SEWAGE DISPOSAL SYSTEM

DEPARTMENT OF HEALTH AND MENTAL HYGIENE

A REPAIR

PROPERTY OWNER Wallace Simon

Plot Plan

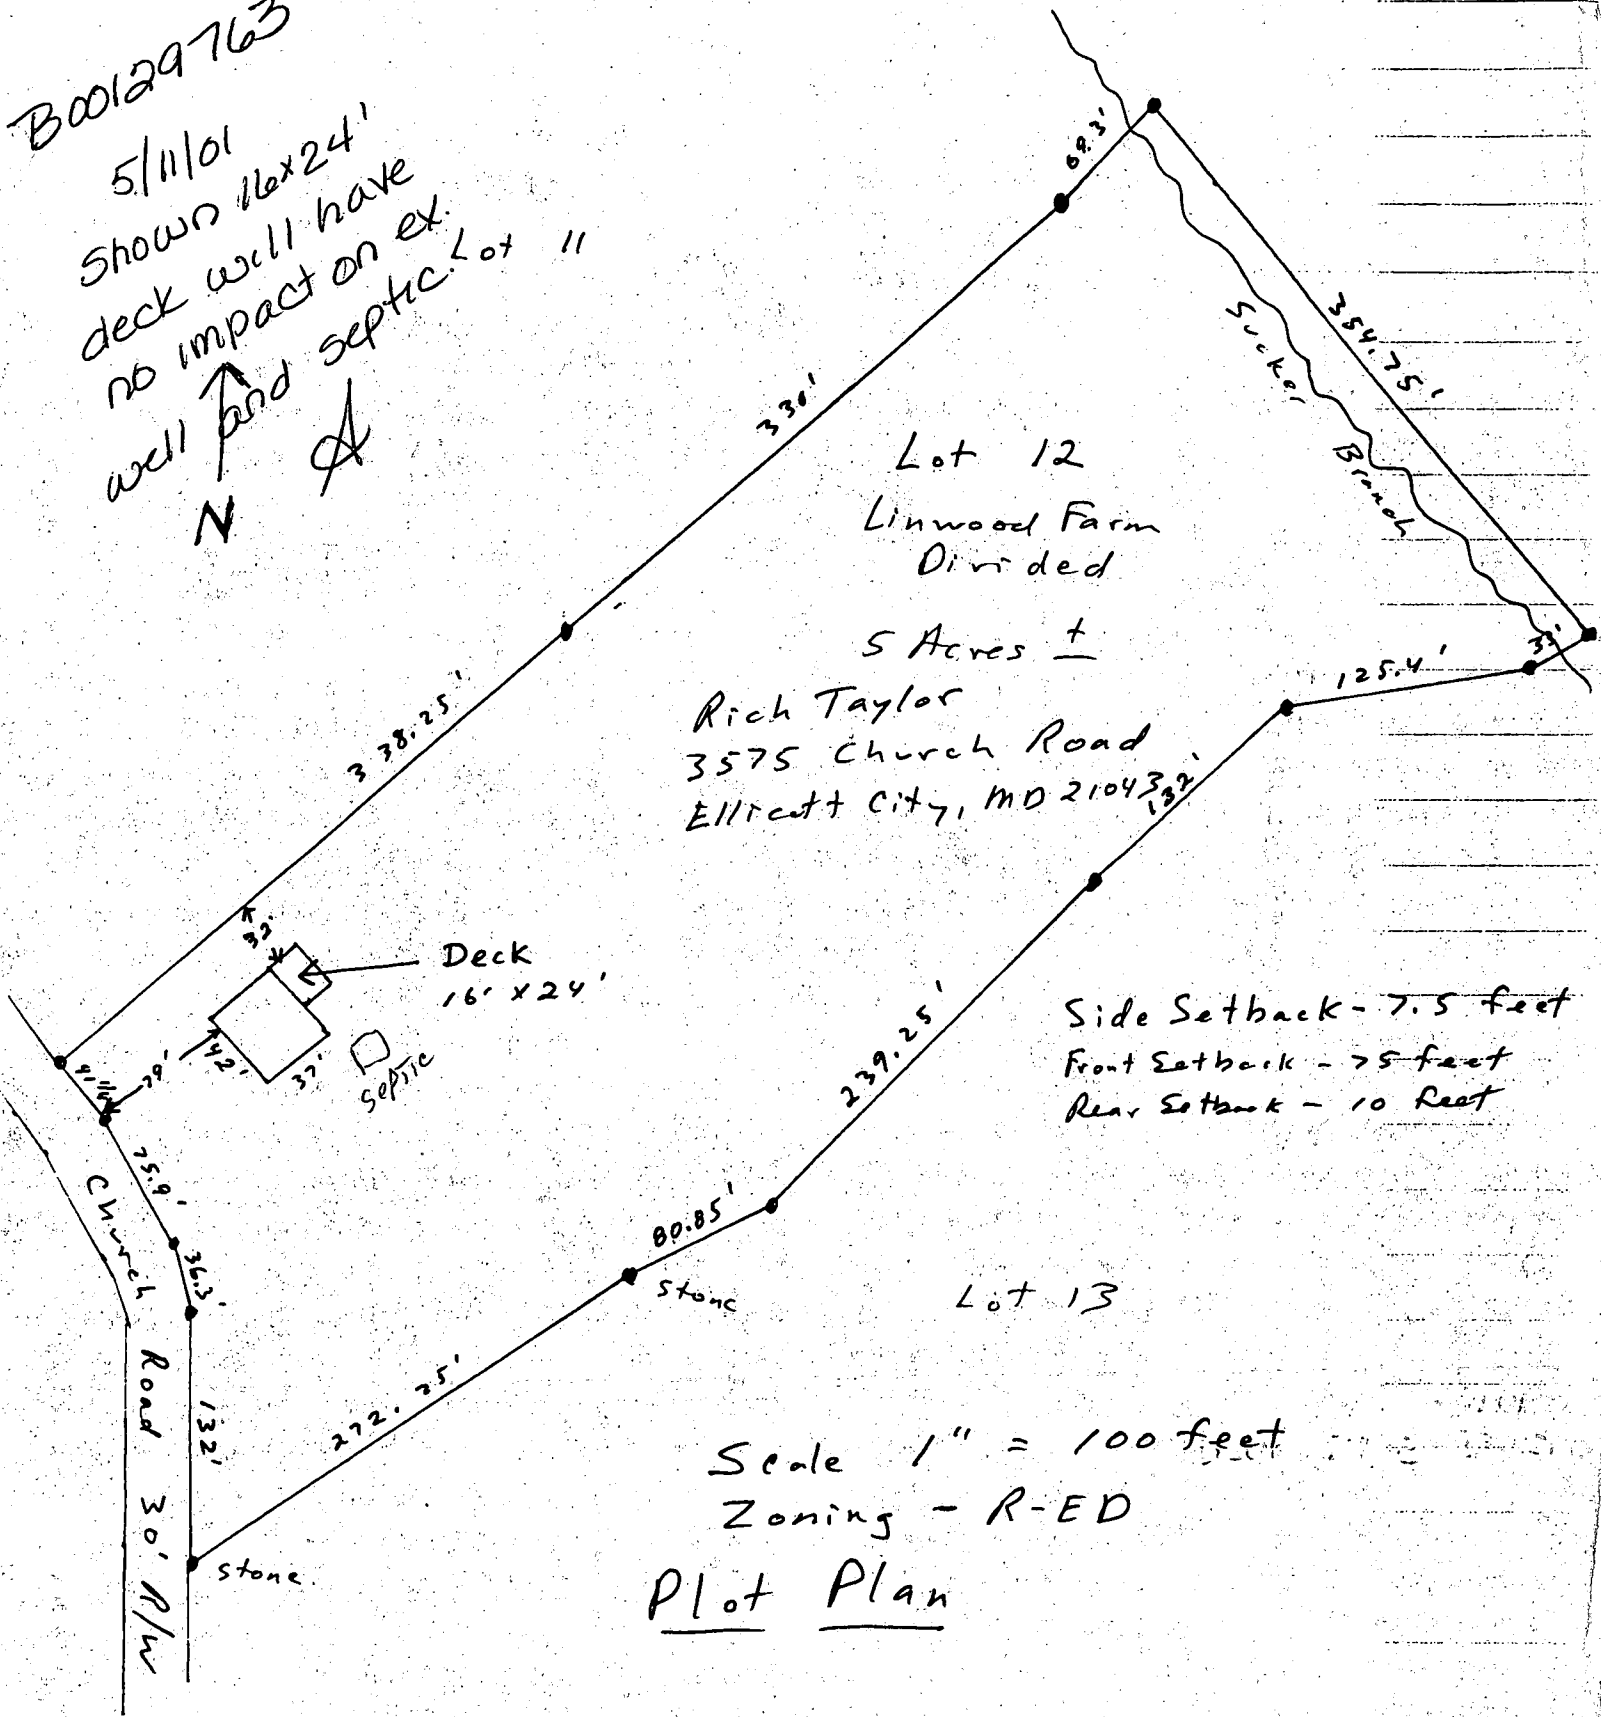
5/11/01
shown 16x24'
deck will have
no impact on ex.
well and septic. Lot 11
